EXHIBIT B

W. 3RD ST & PACIFIC AVENUE

SITE PLAN REVIEW

09.10.2019

CONCEPT SITE PLAN

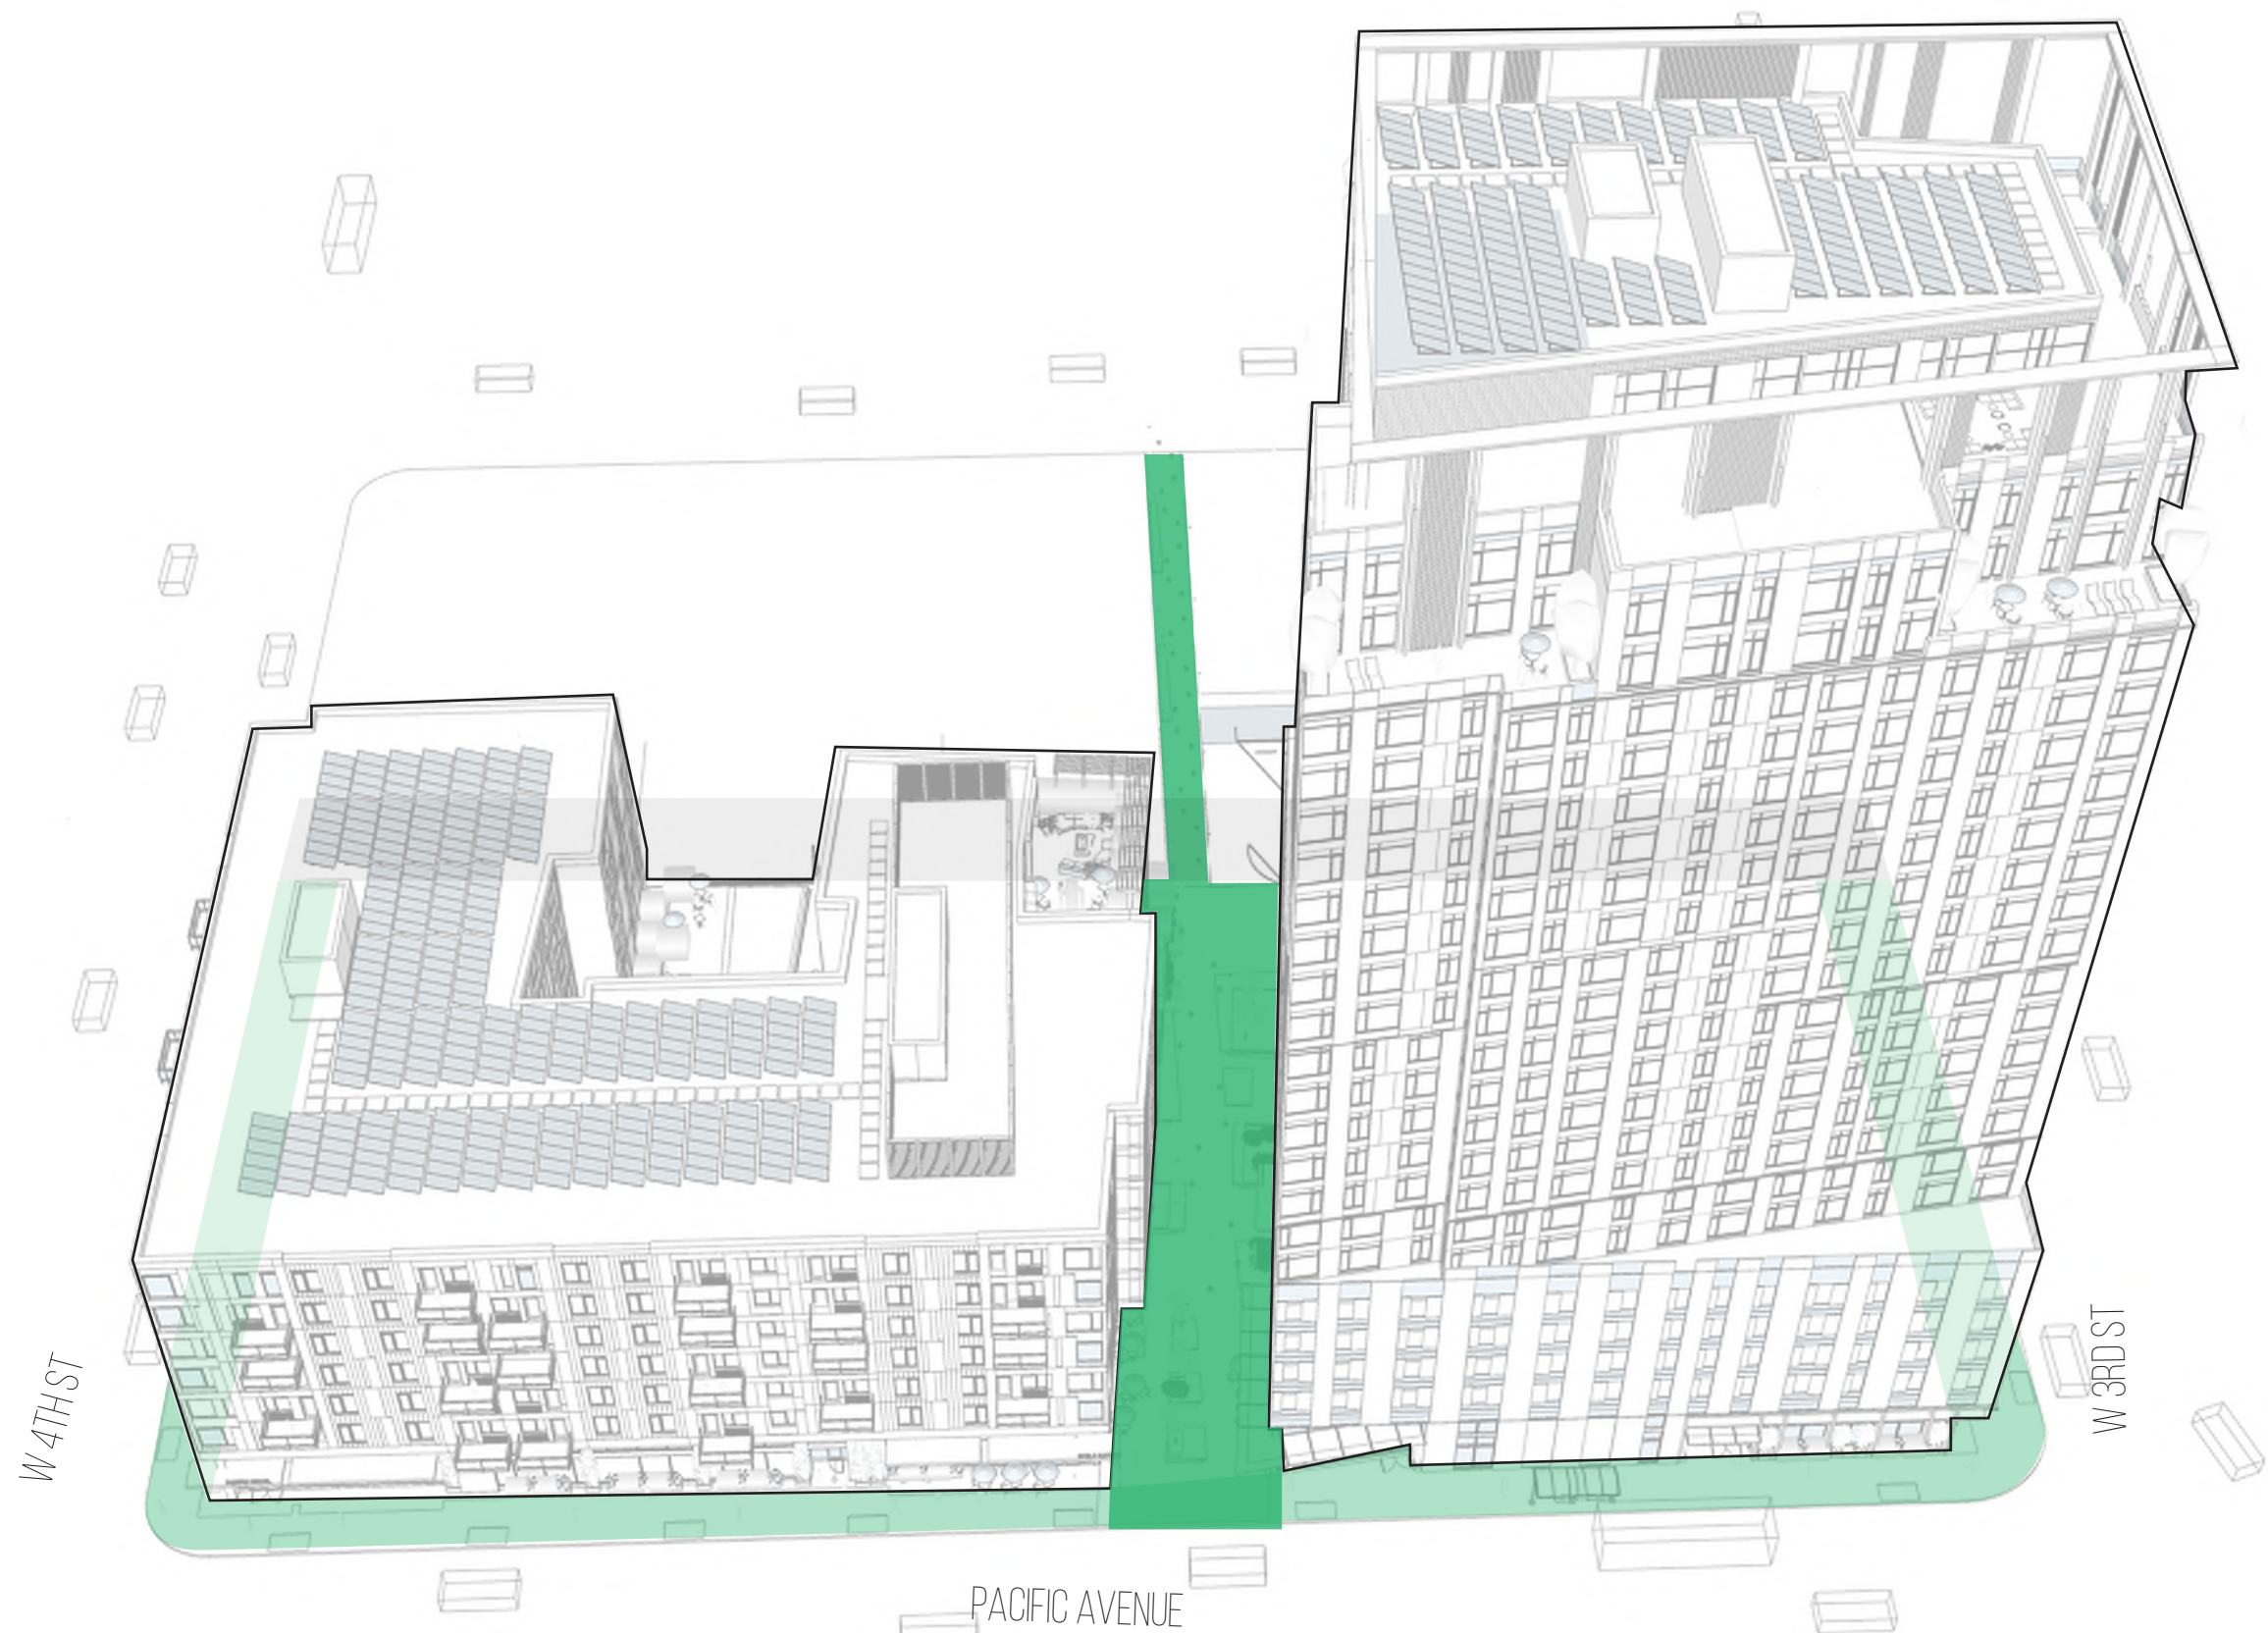
b. Building sections are now keyed on the floor plans.
6. Landscaping
- a. Landscaping within the parkway. The concept site plan on page 4 (landscape appendix) has been revised to show landscaping within the parkway, in compliance with the Downtown Plan.

b. Landscaping along the base of the buildings. The concept site plan on page 4 (landscape appendix) has been revised to show planting abutting the building walls facing streets.
